Construction of a costly latrine.

Informing, with remark, the President, Taluk Board, Narsapur, that his action in disregarding G.O., No. 79 L., dated 16th May 1891, and the advice of the Sanitary Commissioner was irregular and meets with the disapproval of Government.

Disapproving of the plan and estimate for enclosing a piece of land to serve as a latrine for the union of Narsapur.

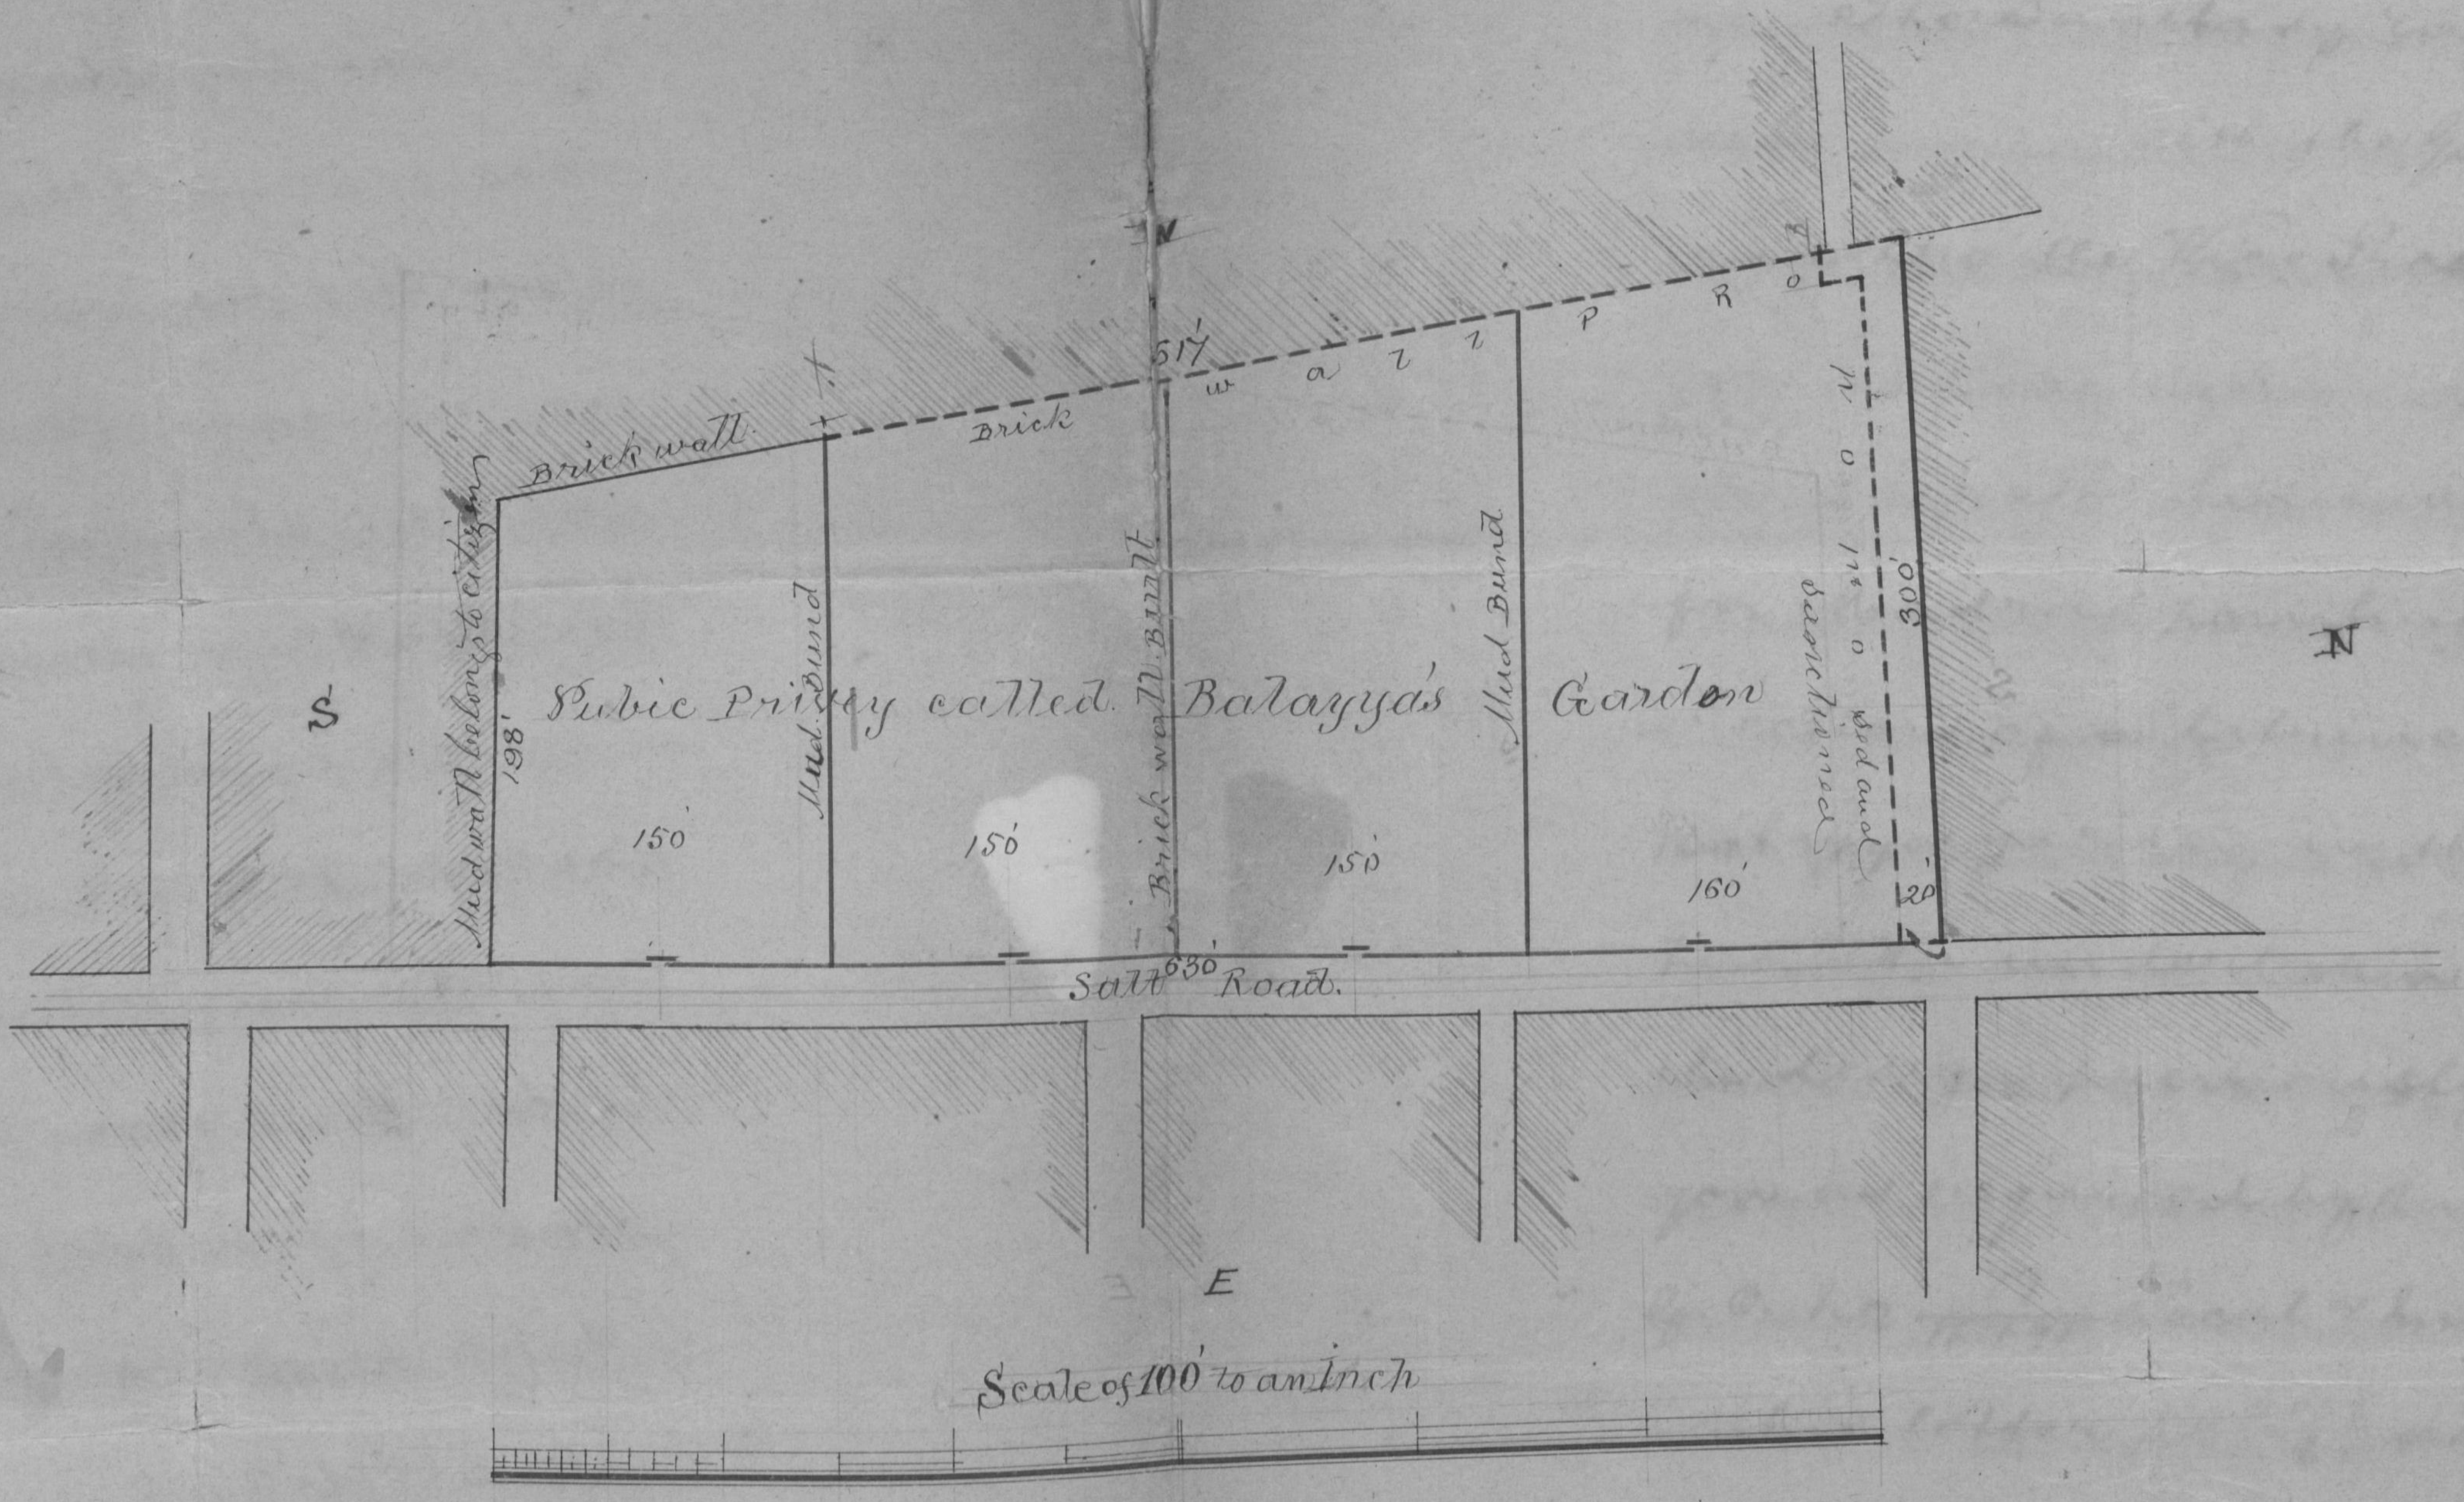
of the Sanitary Board, Madras. So far as I can see, it is not a latrine at all strictly speaking but what the union has done is to clear and enclose a piece of waste land long used as a latrine and to divide it into compartments for separate use by men and women (vide plan of the project enclosed for perusal and favour of return). This is not perhaps a very decent kind of latrine but I am not sure that it is not a healthier one than the small masonry latrines generally met with which often ~~smell~~ smell abominably. The much larger area probably more than compensates for the flooring not being impermeable &c,

consideration though no doubt necessary for the purpose of decency. An expenditure of Rs 800 has already been made on the same work in the previous year. The total expenditure will thus be about Rs 2,000. When compared with results this large expenditure must be considered most injudicious. For the sum of Rs 2000 about six latrines of correct design could have been erected and these probably would have sufficed for the union.

The Sanitary Engineer cannot approve of the proposals made.
